Delegated Report

Householder Planning Application

Application No:	20211085
Location:	23 Frobisher Way, Gravesend, Kent, DA12 4QY
Description:	**REVISED DESCRIPTION** Retention of two storey front extension, porch, rear dormer and summerhouse; and erection of a single storey rear extension in substitution for the two storey extension permitted under 20200512.
Applicant:	Nithoyakala Santhiapillai
Site Visit:	26/10/2021

Dormer Extension:

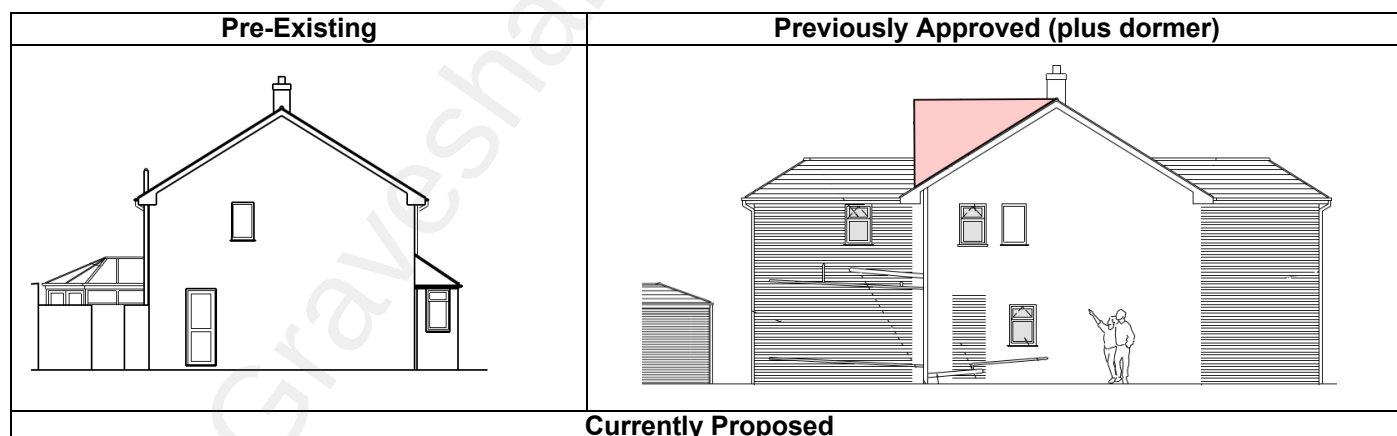
- Depth - 3.65m
- Width - 5.78m
- Height - 2.15m
- Volume - 22.68m²

The extensions to the dwelling are considered to be acceptable in terms of design. The main material change to the development previously approved (ref. 20200512) is the new dormer window and the reduction of the two storey rear extension, to a single storey. The reduction of the two storey rear extension to a single storey is a significant improvement given that the dormer is already constructed. This change reduces the overall bulk, resulting in a development that is more sympathetic and proportionate to the scale of the original dwelling.

There are no new flank windows proposed in the development. The dormer window was constructed in accordance with Class B of the Town and Country Planning (General Permitted Development) (England) Order 2015, as amended, and therefore cannot be a reason to refuse this application. Nevertheless, the dormer is not considered to detrimentally impact on the private amenity space of neighbouring properties, above the existing rear windows on the property.

Summerhouse/Outbuilding:

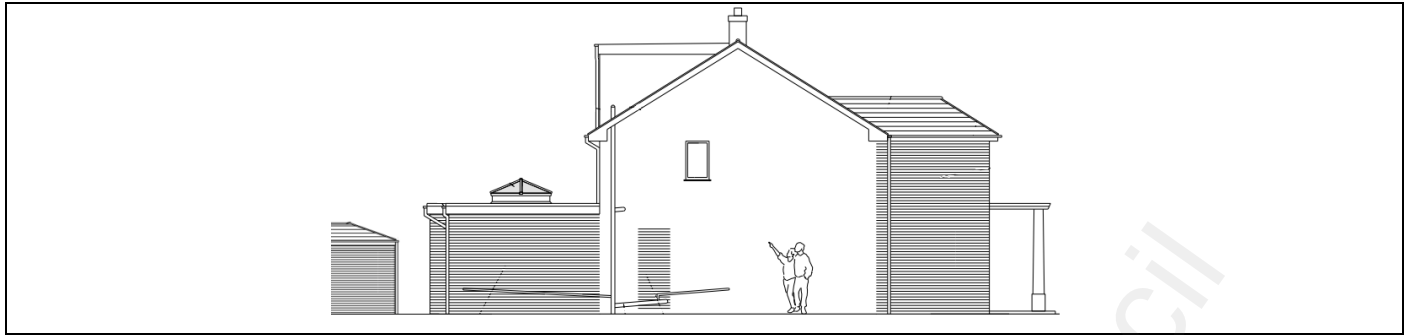
Ward Councillor - I am concerned with the height of the proposed summer house. This will overlook the garden of the house to the rear of the property and recently this very issue caused complaints on another planning application. Perhaps a flat roof would be a better option.

- Depth - 8.8m
- Width - 2.93m
- Height - 2.925m

The front extension and outbuilding have not materially changed as part of this development in terms of size. However, the outbuilding has changed from a garage to a summerhouse. As such, the garage doors have been removed and replaced by a small forward facing window. This does not have any significant impact on the street scene as the structure is set-back from the highway by 23m.
